Access Compliance Report

Public Rights-of-Way

(Curb Ramps)

Intersection ID: 53359	Main Street: GARABRANDT_LN	Cross Street: LAMAR_AV	Location: NE
ADA ID: 4DABD9EDD153	Ramp Type: BlendTrans1	Initial Pass/Fail: Pass	Overall Compliance: No
Severity Score: 2.5			
Codes/Mitigation Info/Possible Solution		Field Measurements/Component Compliance

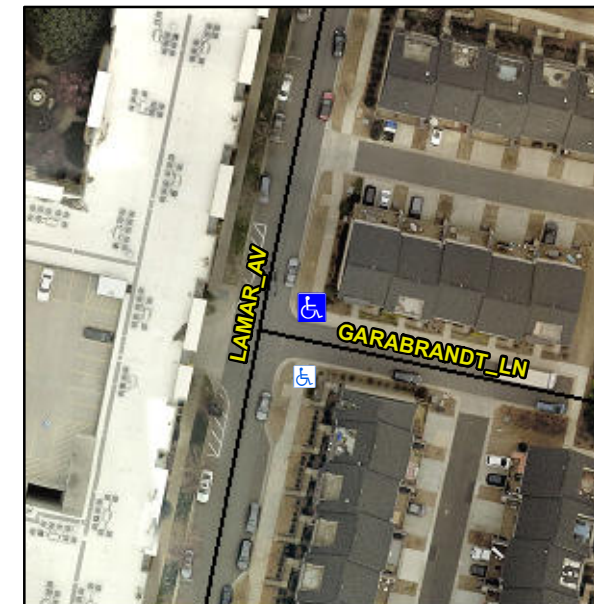
Not Found, R304.2.2-Perp, R304.3.2-Para, R304.5.3, R305.1.4, R305.2

Compliance	Description	Data	Compliance	Description	Data
N/A	Ramp Length (in)	142.5	Yes	BlendTrans Slope (%)	3.1
Yes	Ramp Width (in)	68.5	Yes	BlendTrans XSlope (%)	1.9
Yes	Flare Type L	Curbed_NoWalkSurface	N/A	Flare Type RT	None
N/A	Flare Slope LT (%)	N/A	N/A	Flare Slope RT (%)	N/A
N/A	Flare Traversable LT?	No	N/A	Flare Traversable RT?	N/A
Yes	Landing Length (in)	71.0	Yes	DWS Provided?	Yes
Yes	Landing Width (in)	71.5	Yes	DWS Contrast?	Yes
No	Landing Slope (%)	2.9	Yes	DWS Length (in)	24.0
No	Landing X Slope (%)	3.1	No	DWS Full Width?	No
N/A	Landing Curb? (Y/N)	No	No	DWS Offset (in)	71.5
N/A	Shared Landing?	No			
Yes	Gutter Ponding?	No	Yes	Gutter Slope (%)	2.6
Yes	Gutter Lip Ht (in)	0.0	Yes	Gutter X Slope (%)	1.9
N/A	Painted X Walk1?	No	N/A	Painted X Walk2?	N/A
	X Walk 1 Direction	To S		X Walk 2 Direction	N/A
	X Walk 1 Width (in)	N/A		X Walk 2 Width (in)	N/A
	X Walk 1 Slope (%)	1.6		X Walk 2 Slope (%)	N/A
	X Walk 1 X Slope (%)	0.9		X Walk 2 X Slope (%)	N/A

N/A	Ramp inside XWalk1?	N/A	N/A	Ramp inside XWalk2?	N/A
	Road Slope (%)	0.9		Clear Space?	Yes
	Road X Slope (%)	1.6	N/A	Clear Space to XWalk (in)	N/A
Yes	Any Obstructions?	No	Yes	Storm Grate/Utility Hazard?	No
	Obstruction Type			Storm Grate/Utility Type	
			N/A		N/A
			Yes	Surface Condition? (G/P)	Good
			No	Curb Slope (%)	6.3

Remove & Replace Curb Ramp With Two New Directional Ramps or Equivalent.
